ADDENDUM NO. 3

June 15, 2026

This Addendum forms a part of the Contract Documents and modifies the original Bidding Documents dated May 4, 2026.

Drawing Sheet/Detail Number: E602

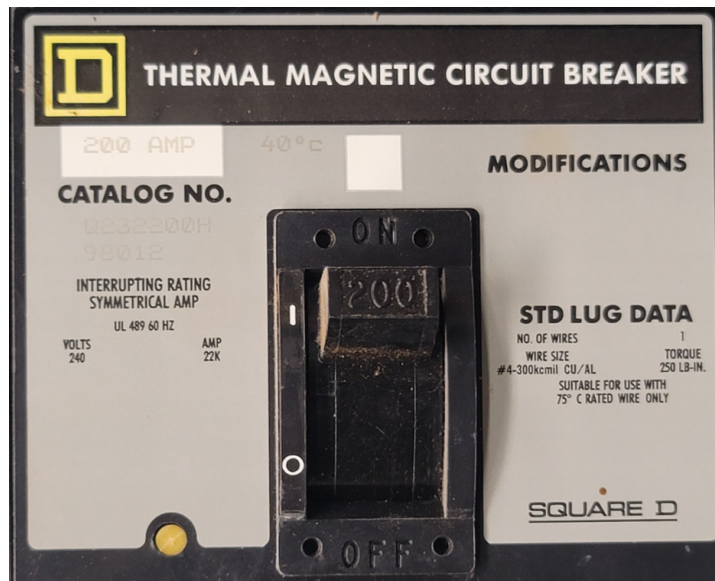
– Is the manufacturer/model/part number of the existing MDP available?

RESPONSE: The MDP manufacturer is Square D. The model number is unavailable. Catalog # of 200 Amp breaker is: Q232200H. Photos of the existing breakers are below.
